Access Compliance Report

Public Rights-of-Way

Intersection ID: 10022558	Main Street: CARMEL_COMMONS_BV	Cross Street: N/A	Location: NW
ADA ID: 5213032456BB	Ramp Type: PerpDiag	Initial Pass/Fail: Fail	Overall Compliance: No
Severity Score: 36.25			
Codes/Mitigation Info/Possible Solution		Field Measurements/Component Compliance

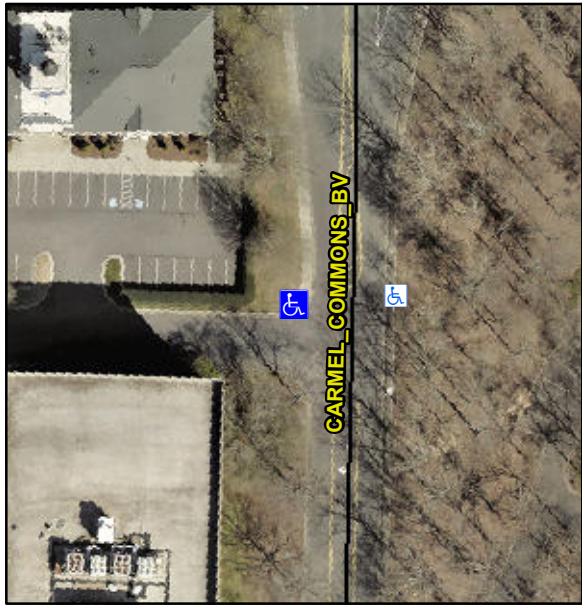
Possible Solutions:		Compliance		Description		Data	Compliance		Description		Data
	Remove & Replace Curb Ramp With Two New Directional Ramps or Equivalent.		N/A	Ramp Length (in)	73.5	Yes	Ramp Slope (%)	7.1				
			No	Ramp Width (in)	31.0	No	Ramp XSlope (%)	2.4				
			N/A	Flare Type LT	N/A	N/A	Flare Type RT	N/A				
			N/A	Flare Slope LT (%)	N/A	N/A	Flare Slope RT (%)	N/A				
			N/A	Flare Traversable LT?	N/A	N/A	Flare Traversable RT?	N/A				
			N/A	Landing Length (in)	N/A	N/A	DWS Provided?	N/A				
			N/A	Landing Width (in)	N/A	N/A	DWS Contrast?	N/A				
			N/A	Landing Slope (%)	N/A	N/A	DWS Length (in)	N/A				
			N/A	Landing X Slope (%)	N/A	N/A	DWS Full Width?	N/A				
Surveyor Notes:		N/A	N/A	Landing Curb? (Y/N)	N/A	N/A	DWS Offset (in)	N/A				
			N/A	Shared Landing?	N/A							
PROW/ADA:			N/A	Gutter Ponding?	N/A	N/A	Gutter Slope (%)	N/A				
			N/A	Gutter Lip Ht (in)	N/A	N/A	Gutter X Slope (%)	N/A				
			N/A	Painted X Walk1?	No	N/A	Painted X Walk2?	No

X Walk 1 Direction	To S		X Walk 2 Direction	To E				
			N/A	X Walk 1 Width (in)	N/A	N/A	X Walk 2 Width (in)	N/A				
				X Walk 1 Slope (%)	3.5		X Walk 2 Slope (%)	1.5				
				X Walk 1 X Slope (%)	5.0		X Walk 2 X Slope (%)	0.3				
			N/A	Ramp inside XWalk1?	N/A	N/A	Ramp inside XWalk2?	N/A				
				Road Slope (%)	1.6	N/A	Clear Space?	N/A				
				Road X Slope (%)	1.8	N/A	Clear Space to XWalk (in)	N/A				
			N/A	Any Obstructions?	N/A	N/A	Storm Grate/Utility Hazard?	N/A				
				Obstruction Type			Storm Grate/Utility Type					
						N/A						N/A
							Yes	Surface Condition? (G/P)	Good
